Agenda
Village of Arlington Heights
Design Commission
Community Room, 3rd Floor
Arlington Heights Village Hall, 33 S. Arlington Heights Rd.
August 13, 2024
6:30 PM

Item: DC#24-028(H) - 702 N. Dunton Ave. - SF/Addition

STAFF DESIGN COMMISSION REPORT

Project Name: 702 N. Dunton Ave.
Project Address: 702 N. Dunton Ave.
Prepared By: Steve Hautzinger

VIEW WEST ON NORTH DUNTON AVENUE

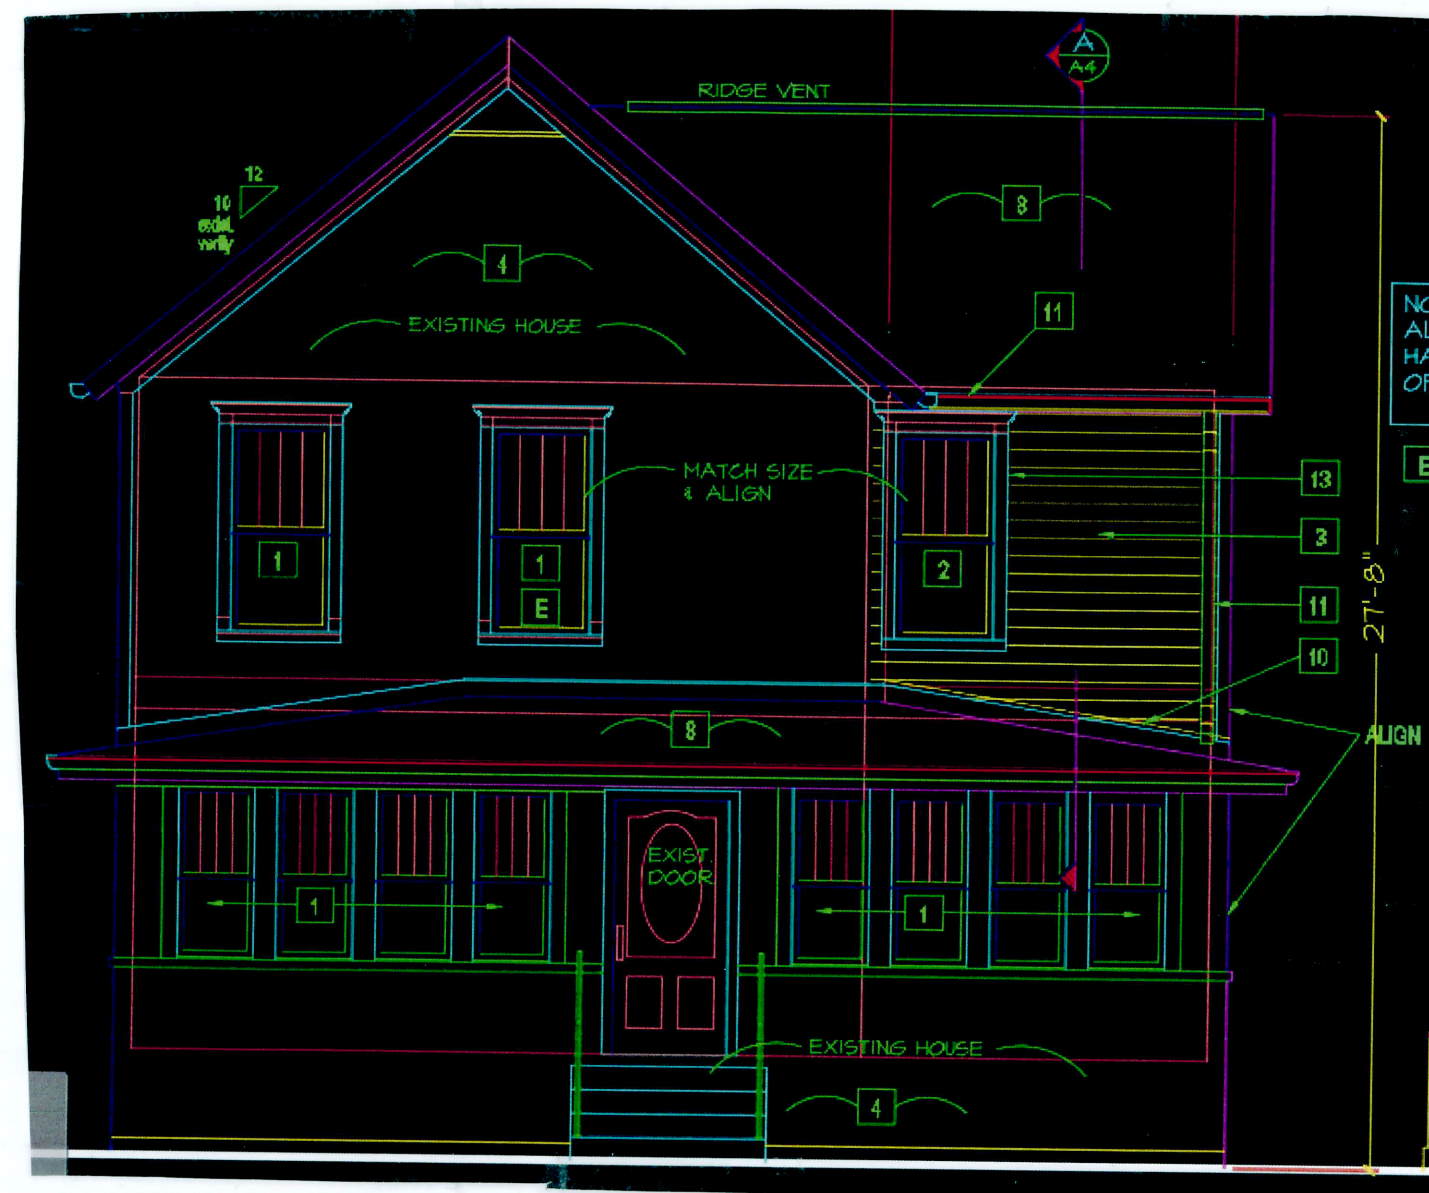
There is an error on Page 4 of the exhibits entitled "View west on North Dunton Avenue." Looking at the 716 N Dunton images shown on Page 4 the petitioner shows the correct photo of the 716 structure, but shows a rendering of the single family home they had proposed to build at 716 if the demolition of the existing 716 N Dunton structure had not been denied by the Design Commission and the Village Board. To us, this is incorrect.
